## 9 Cathedral Square - Tree Assessment

This tree report was commissioned by Lynette Ellis, Manager Planning and Delivery - Transport, Christchurch City Council. The report provides an assessment of potential effects and tree related recommendations for the proposed development of 9 Cathedral Square.

The proposal includes the construction of building foundations and a canopy supported by pillars, the relocation of underground utility services and changes to levels within the vicinity of three Common Lime (*Tilia x europaea*) trees in raised planters on the southern side of Cathedral Square.

Figure 1: Proximity of the proposed building canopy to the trees.

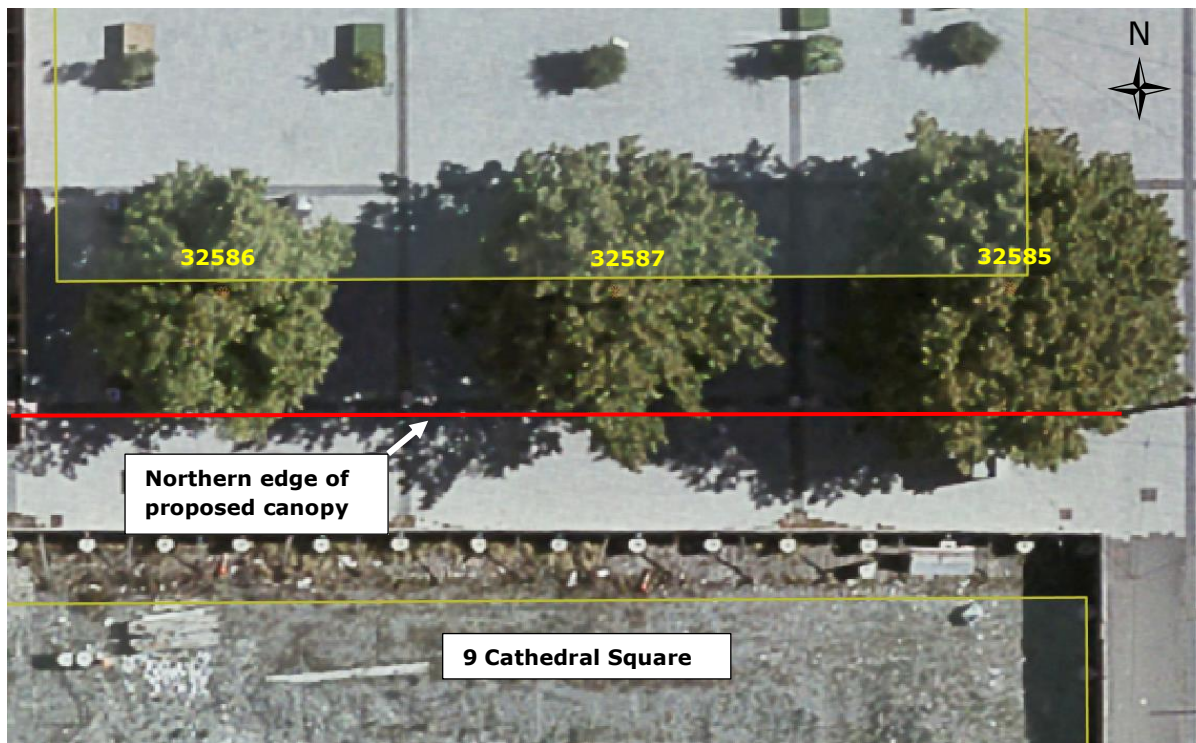
The proposed building canopy will encroach into the tree canopies (as shown in Figure 1 below).

At the site meeting the applicant confirmed that the building canopy and pillars can be installed with only minor tree pruning being required, as those features are modular and can be craned into place and attached without affecting the trees.

The applicant also confirmed that additional pruning for construction access and scaffolding will not be required. This will negate the potential risk of additional pruning being required during construction.

Minor pruning within the upper tree canopies will be required for construction and initial tree clearance from the northern edge of the building canopy.

It is expected that the majority of the tree canopies can be retained under the building canopy, and minor pruning may be required for construction and initial clearance of the pillars.

The existing standard is to provide at least 1.0m clearance from buildings/structures, and this extent of pruning is not expected to result in a significant change to the shape of the trees.
